Seismic Walkdown Checklist (SWC)

Equipment ID No. 1-1467-PS-565 Equip. Class¹² INSTRUMENT RACKS - CLASS 1B

Equipment Description 5GB ISOL SOLENOID RACK

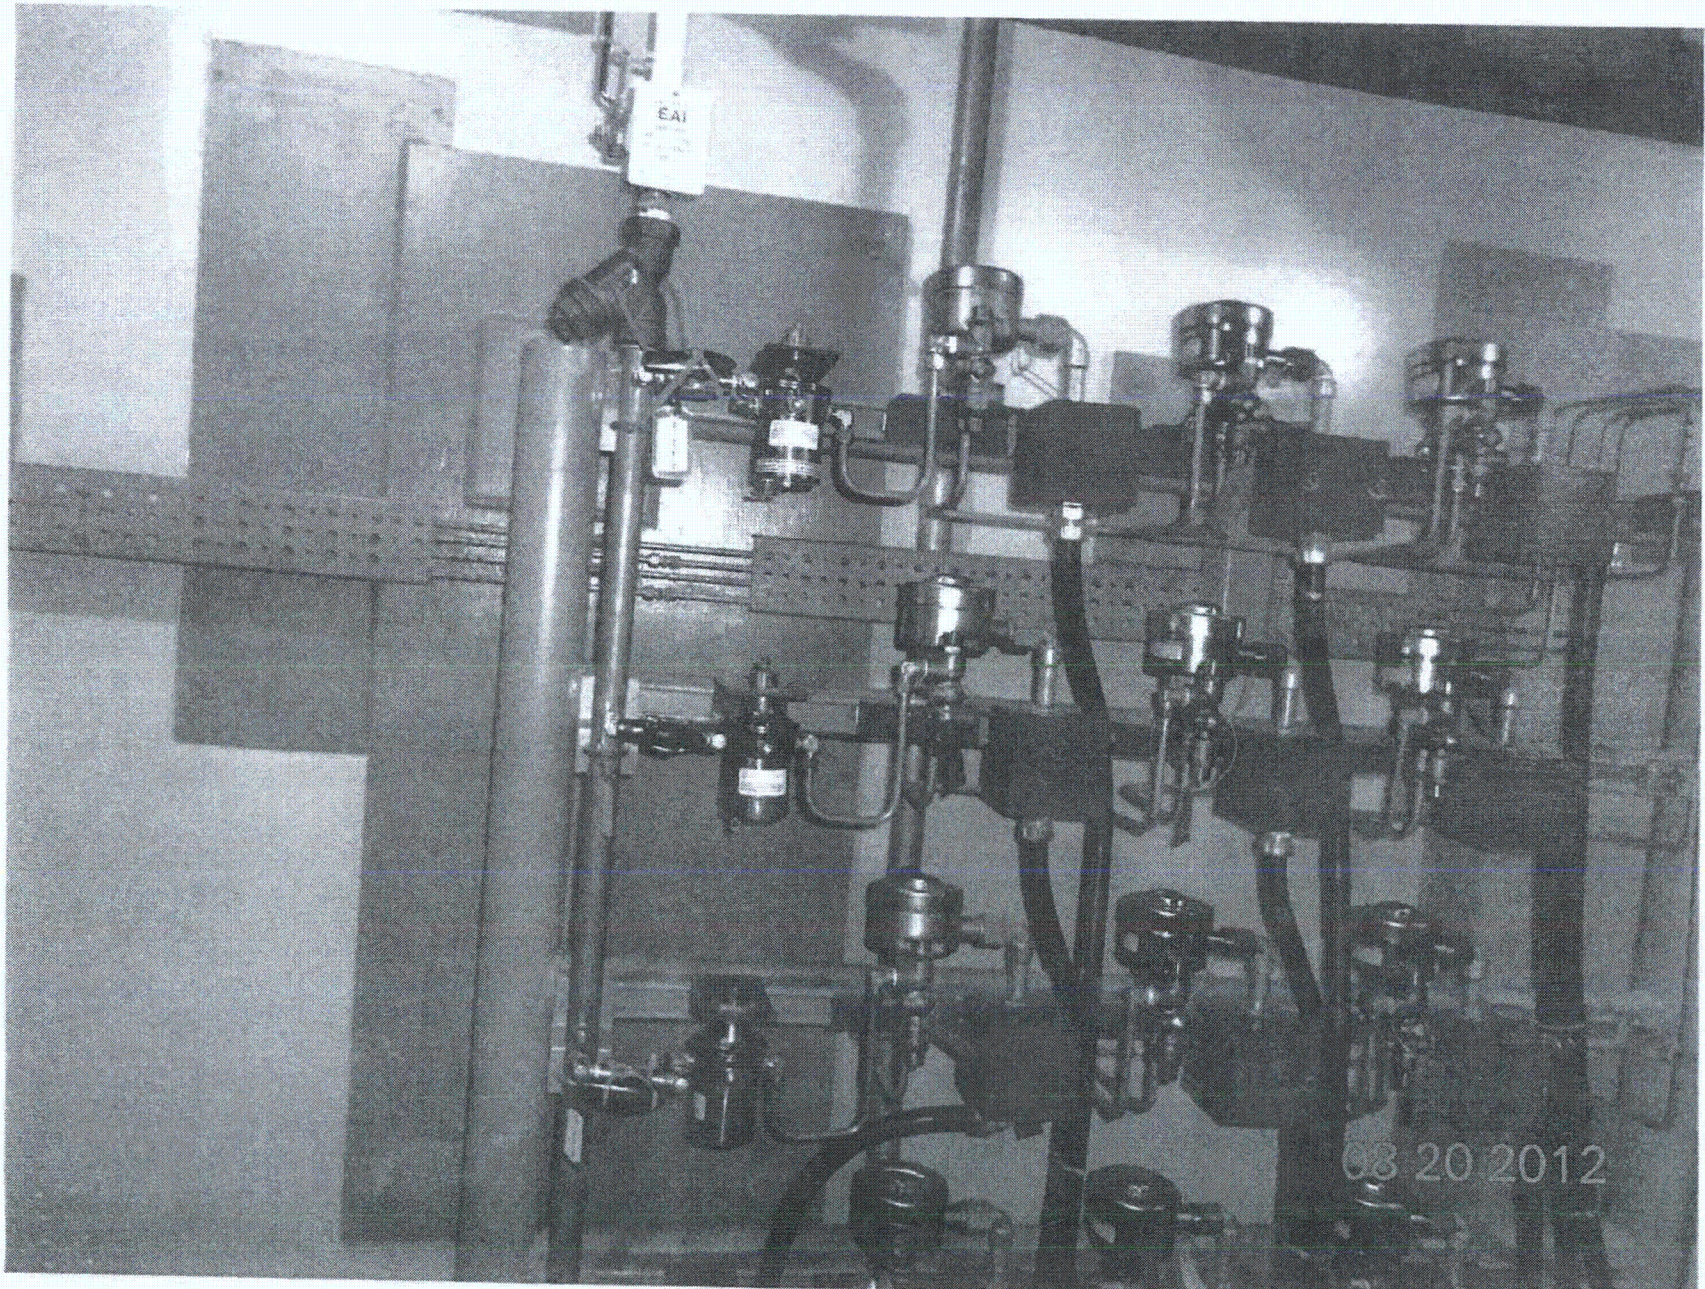
INSTRUMENT AIR LINE - BOLTS NUTS LOOSE @ TOP & BT
NOT A SEISMIC CONCERN
SEE CR # 505329

Equipment ID No. I-1500-Q5-HVC Equip. Class¹² 20

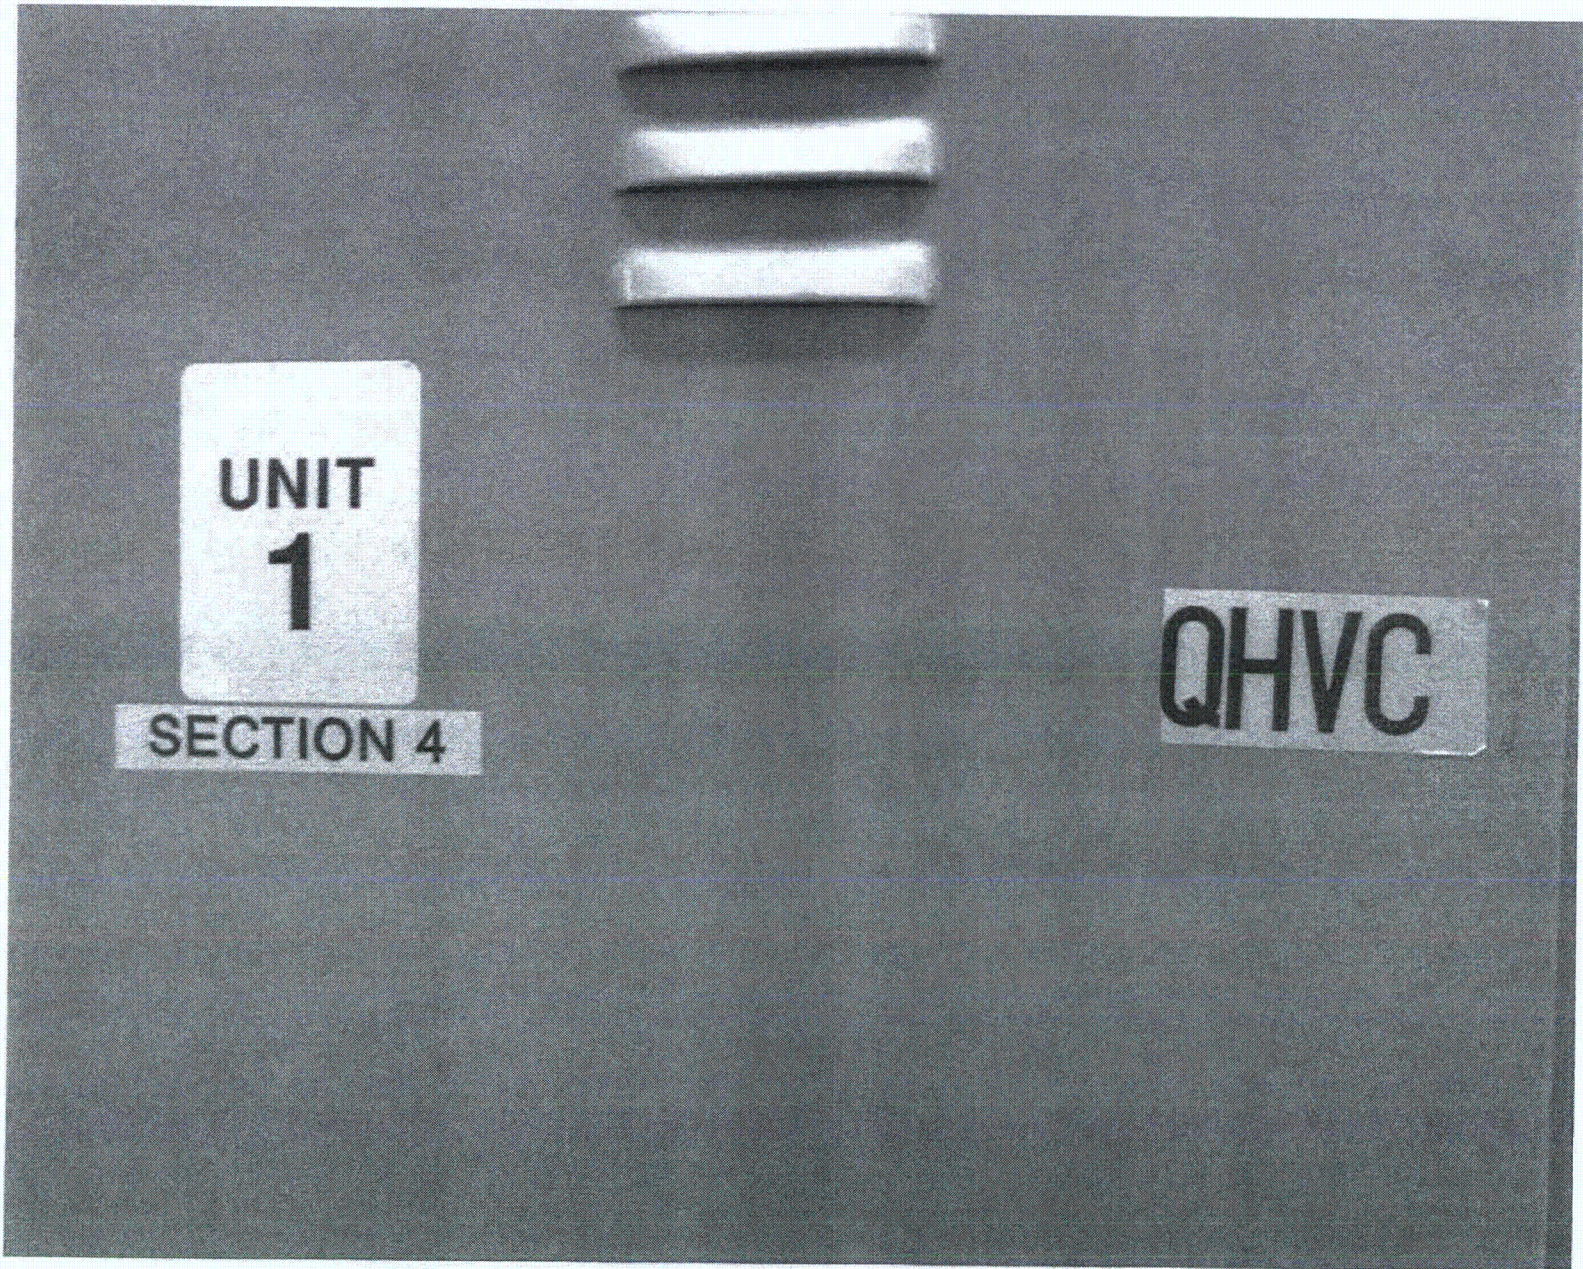
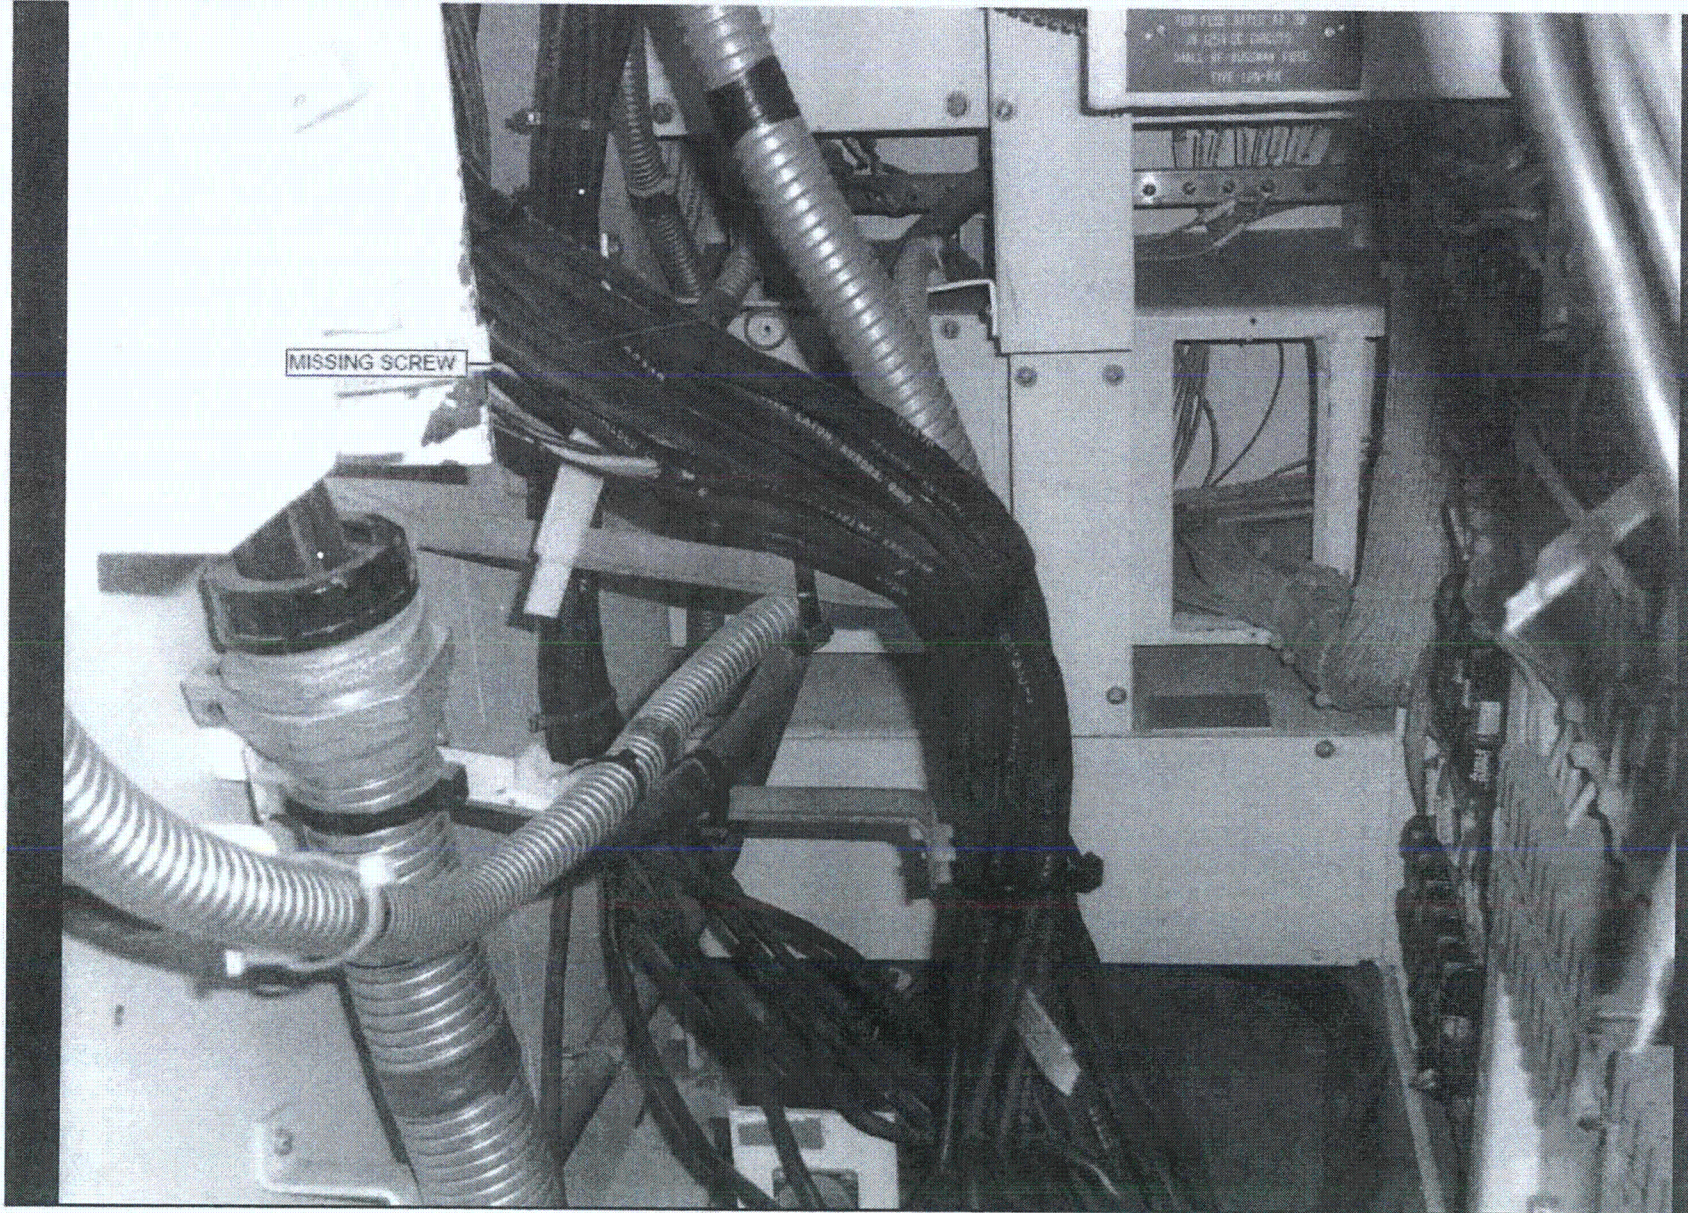
SOME NUTS AND SCREENS USED TO SECURE PROTECTIVE COVERS, LINK BLOCKS, & CONDUITS SUPPORT INSIDE THE CABINET ARE MISSING. THESE FINDINGS ARE OCCURRING RANDOMLY THROUGHOUT THE CABINET'S SECTIONS 1 THROUGH 4. THIS CONDITION HAS BEEN SUBMITTED UNDER THE SEISMIC WALKDOWN TEAM JUDGED THAT THIS CONDITION DOES NOT REPRESENT A SEISMIC OR OPERABILITY CONCERN. CR 527556
 ALSO FOUND 1 OF THE RODS THAT LATCHES DOOR IS MISSING. CR 527608 GENERATED

Equipment ID No. 1-1532-A7-001 Equip. Class¹² 10 (Air Handlers)

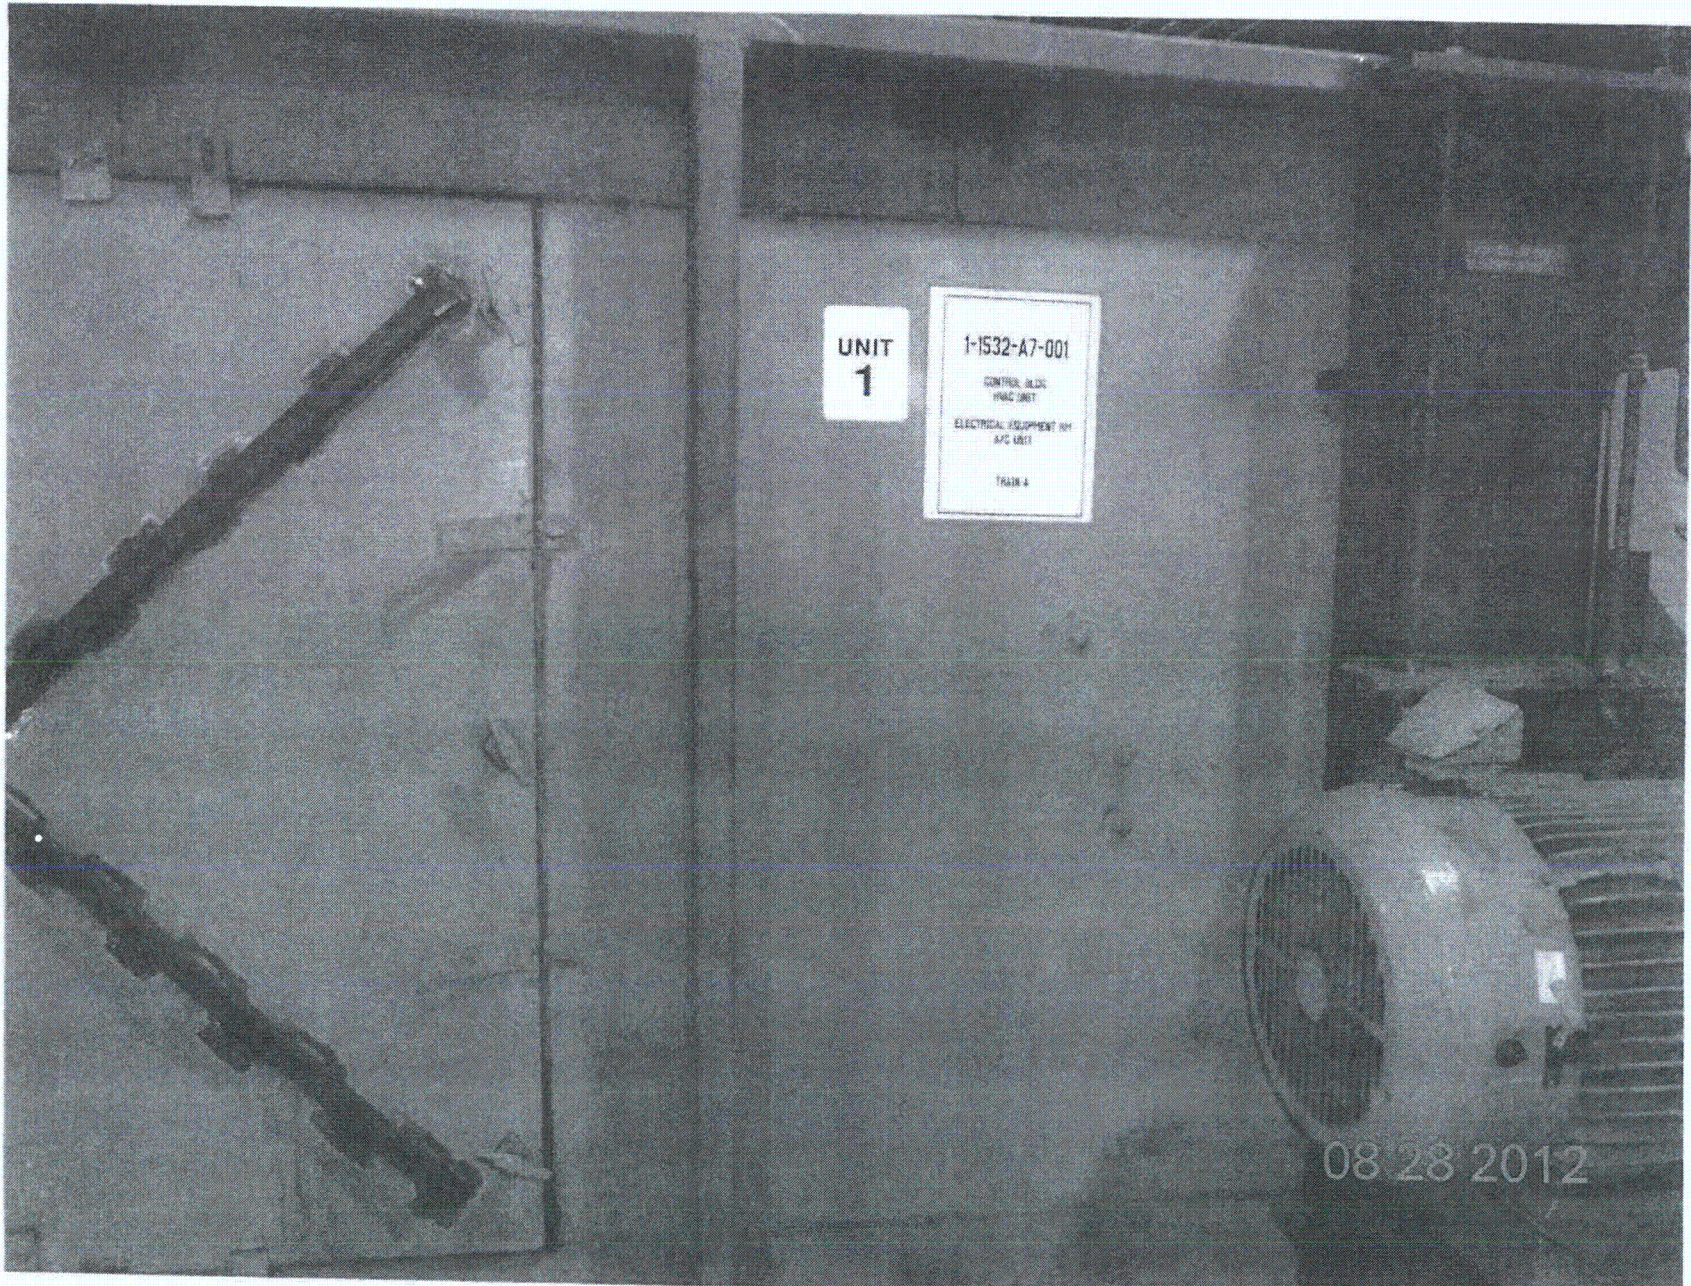
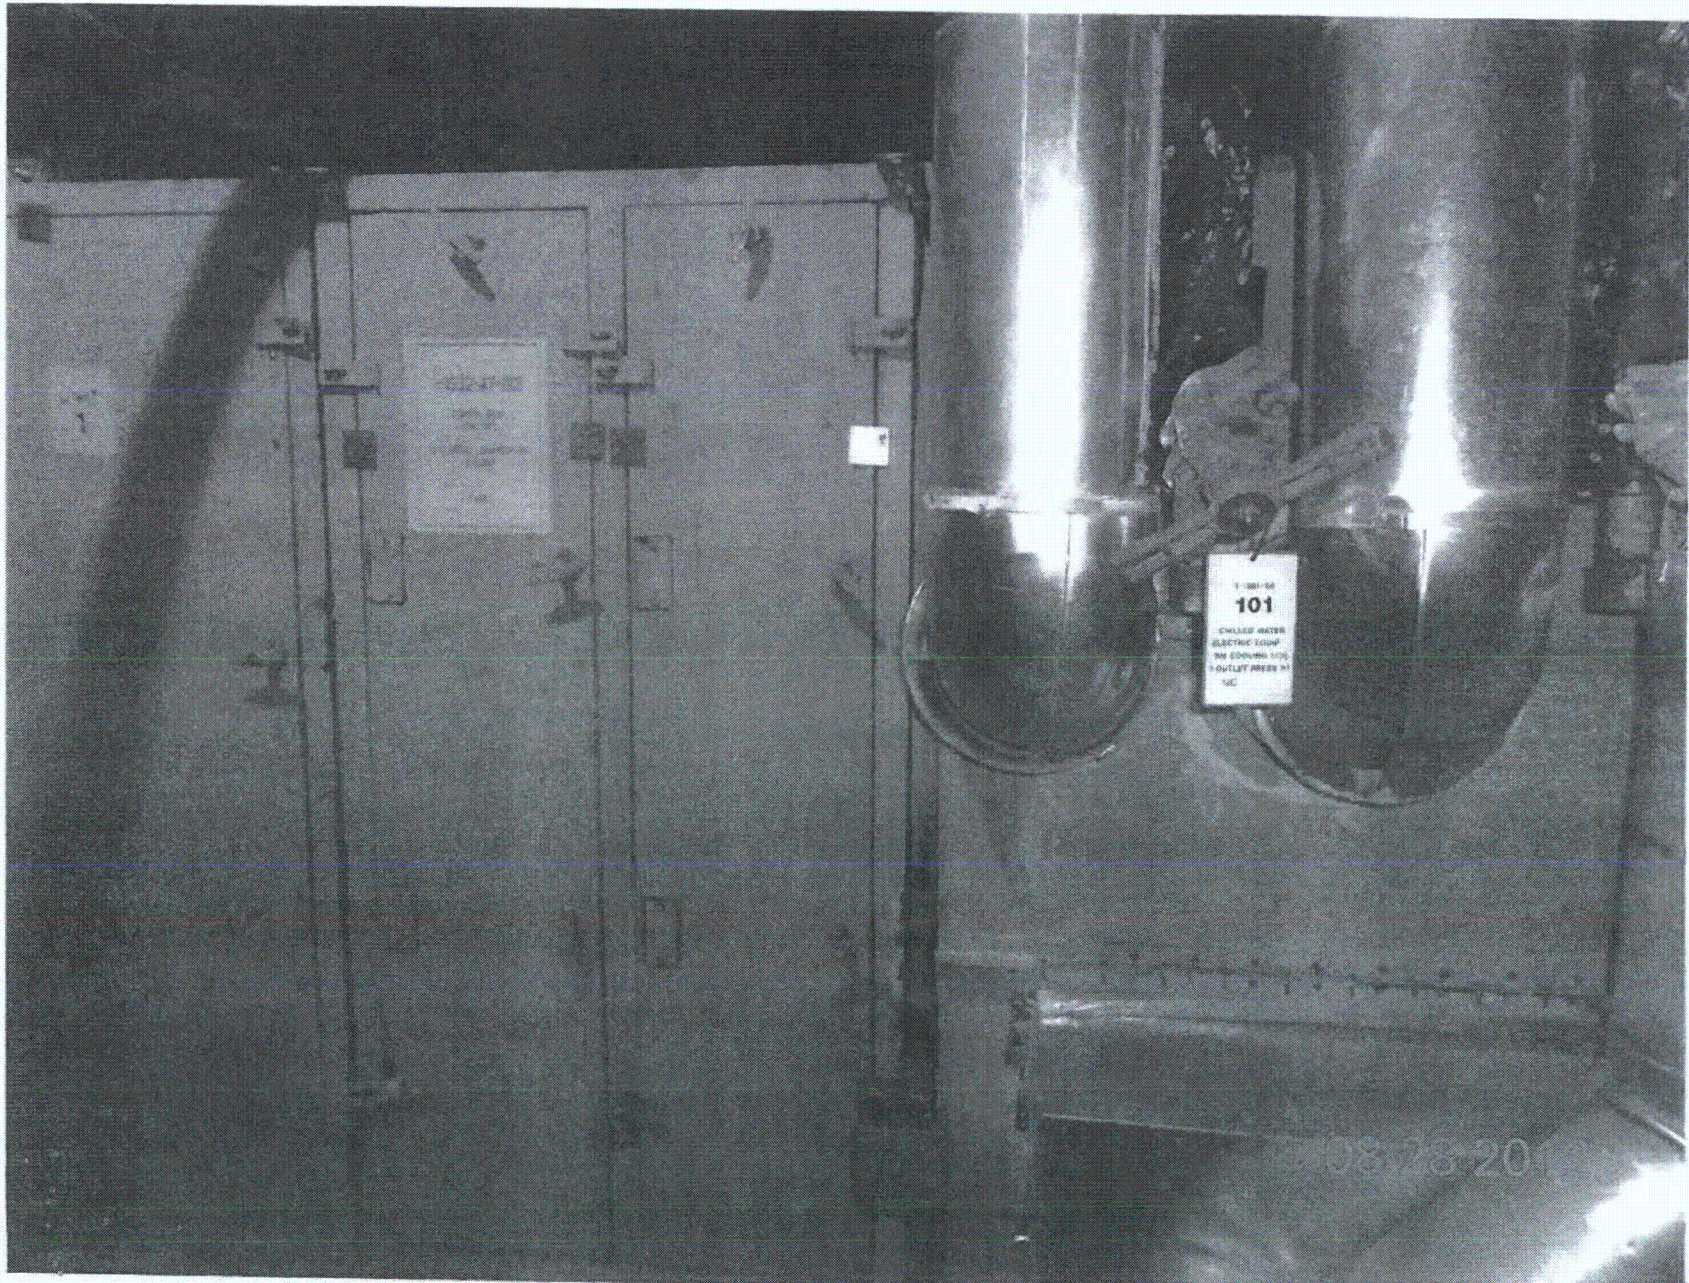
of MHC support
Anchor bolts front / back show sign of corrosion. SNEs judge the condition to be acceptable. However, initiate CR 509130 to track the condition.
